**AGENDA**  
**PLANNING COMMISSION PUBLIC HEARING/REGULAR MEETING**  
**CITY OF FARMINGTON HILLS**  
**APRIL 16, 2026 @ 7:30 P.M.**  
**FARMINGTON HILLS CITY HALL – CITY COUNCIL CHAMBER**  
**31555 W. ELEVEN MILE ROAD, FARMINGTON HILLS, MICHIGAN 48336**  
Cable TV: Spectrum – Channel 203; AT&T – Channel 99  
YouTube Channel: <https://www.youtube.com/user/FHChannel8>  
[www.fhgov.com](http://www.fhgov.com) (248) 871-2540

## **CLUSTER SITE PLAN 59-4-2019**

LOCATION: 29150 Farmington Rd  
PARCEL I.D.: 22-23-10-101-002  
PROPOSAL: One-family cluster option subdivision (10 units) in RA-2, One-Family Residential District  
ACTION REQUESTED: Recommend to City Council  
APPLICANT: Cedar of Farmington, LLC (Ayman Rida)  
OWNER: Cedar of Farmington, LLC

## Cluster Site Plan for The City of Farmington Hills

PROJECT: CEDARS OF FARMINGTON  
PREPARED FOR: CEDARS OF FARMINGTON ROAD, LLC  
TITLE: SITE PLAN

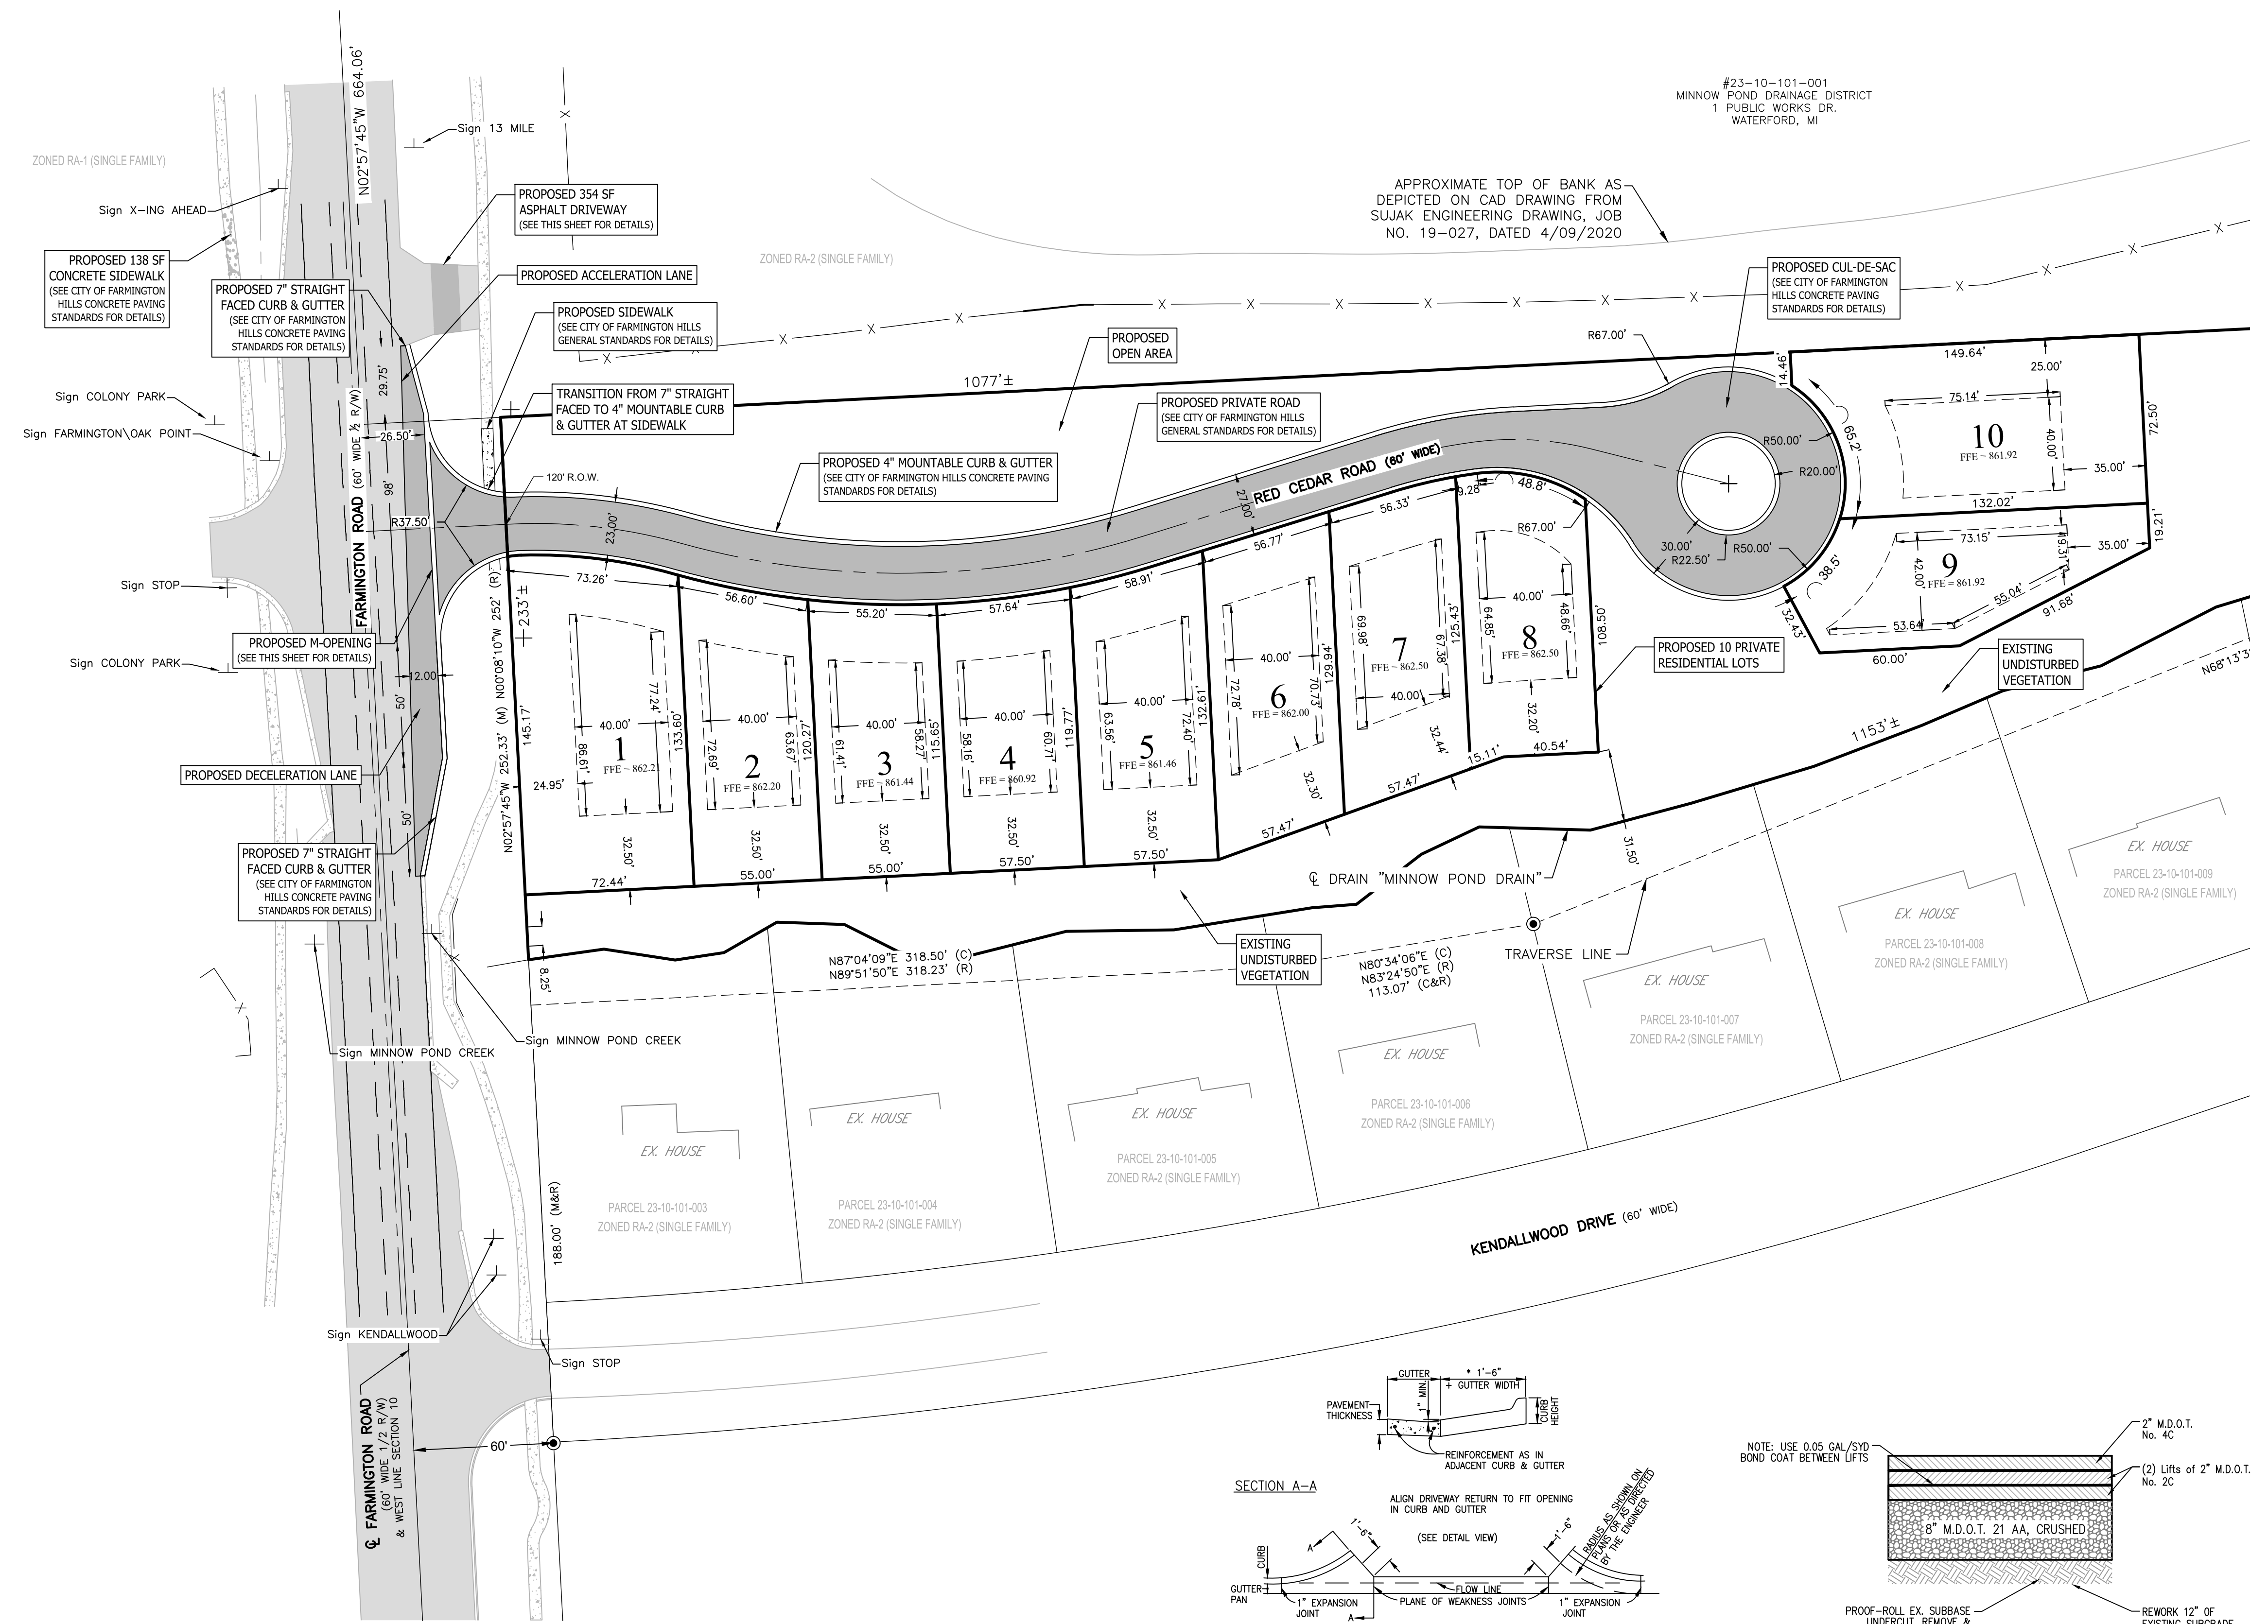
- e. The buildable area of Lot 4 is impacted by encroachment of the 100 year (1% chance) flood hazard area. This should be addressed.
  - f. Floor plans and elevations of typical units have not been provided. These are required per Sec. 3.17.5.C.ii.a.

While the plan includes a proposed open space area, that area is not directly adjacent to the existing subdivision to the south. The cluster development is generally buffered on all sides by a combination of proposed plantings, existing vegetation, and Minnow Pond Creek along the southern edge. However, the southern “buffer” between the cluster development and the neighborhood to the south is shown largely within individual lots. Flood hazard areas are also located within lots.

Recent discussions among City staff have identified a recurring concern with buffers located within private lots: over time, trees and vegetation are often removed or altered by individual property owners, compromising the intended buffering function. Staff and City officials have expressed concern with ensuring the long-term integrity of the southern buffer so the spirit and intent of the ordinance is maintained. This may involve extending open space along Minnow Pond Creek to keep some or all of the buffer out of private lots, or otherwise revising the plan to achieve an equivalent outcome.

- Shift the road along the northern property line to increase open space/buffer area along Minnow Pond Creek and the southern property line; and/or
- Delineate limits of grading and tree removal to demonstrate that Minnow Pond Creek and the existing tree line can be preserved as a functional buffer. Depending on the extent of grading and tree removal, additional plantings may be required to meet Section 34.5.14.6.

1. Shift the road along the northern property line to increase open space/buffer area along Minnow Pond Creek and the southern property line; and/or
2. Delineate limits of grading and tree removal to demonstrate that Minnow Pond Creek and the existing tree line can be preserved as a functional buffer. Depending on the extent of grading and tree removal, additional plantings may be required to meet Section 34.5.14.6.

- Provide updated tree survey and tree mitigation and replacement calculations
- Alter plans based on discussion of the Planning Commission
- Provide typical floor plans and elevations
- Revise plans to meet the design standards of subsection 34-3.17.4.
